Access Compliance Report

Public Rights-of-Way

(Curb Ramps)

Intersection ID: 17531	Main Street: HILLSIDE_AV	Cross Street: WESTFIELD_RD	Location: SE
ADA ID: 4F256BB78F73	Ramp Type: PerpDiag	Initial Pass/Fail: Fail	Overall Compliance: No
		Severity Score: 35

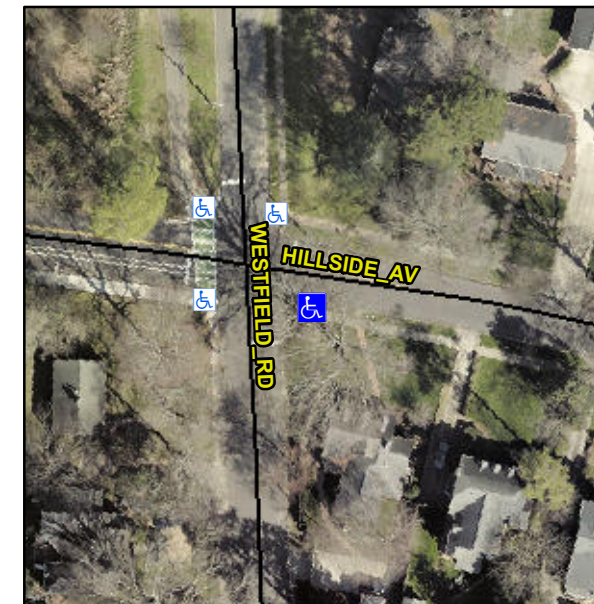
Not Found, R304.5.1, R304.2.2, R304.5.3

Compliance	Description	Data	Compliance	Description	Data
N/A	Ramp Length (in)	56.0	No	Ramp Slope (%)	12.0
No	Ramp Width (in)	47.0	No	Ramp XSlope (%)	4.6
N/A	Flare Type LT	N/A	N/A	Flare Type RT	N/A
N/A	Flare Slope LT (%)	N/A	N/A	Flare Slope RT (%)	N/A
N/A	Flare Traversable LT?	N/A	N/A	Flare Traversable RT?	N/A
N/A	Landing Length (in)	N/A	N/A	DWS Provided?	N/A
N/A	Landing Width (in)	N/A	N/A	DWS Contrast?	N/A
N/A	Landing Slope (%)	N/A	N/A	DWS Length (in)	N/A
N/A	Landing X Slope (%)	N/A	N/A	DWS Full Width?	N/A
N/A	Landing Curb? (Y/N)	N/A	N/A	DWS Offset (in)	N/A
N/A	Shared Landing?	N/A			
N/A	Gutter Ponding?	N/A	N/A	Gutter Slope (%)	N/A
N/A	Gutter Lip Ht (in)	N/A	N/A	Gutter X Slope (%)	N/A
N/A	Painted X Walk1?	No	N/A	Painted X Walk2?	No
	X Walk 1 Direction	To N		X Walk 2 Direction	To NW
N/A	X Walk 1 Width (in)	N/A	N/A	X Walk 2 Width (in)	N/A
	X Walk 1 Slope (%)	6.0		X Walk 2 Slope (%)	2.7
	X Walk 1 X Slope (%)	4.4		X Walk 2 X Slope (%)	3.1

Remove & Replace Curb Ramp With Two New Directional Ramps or Equivalent.
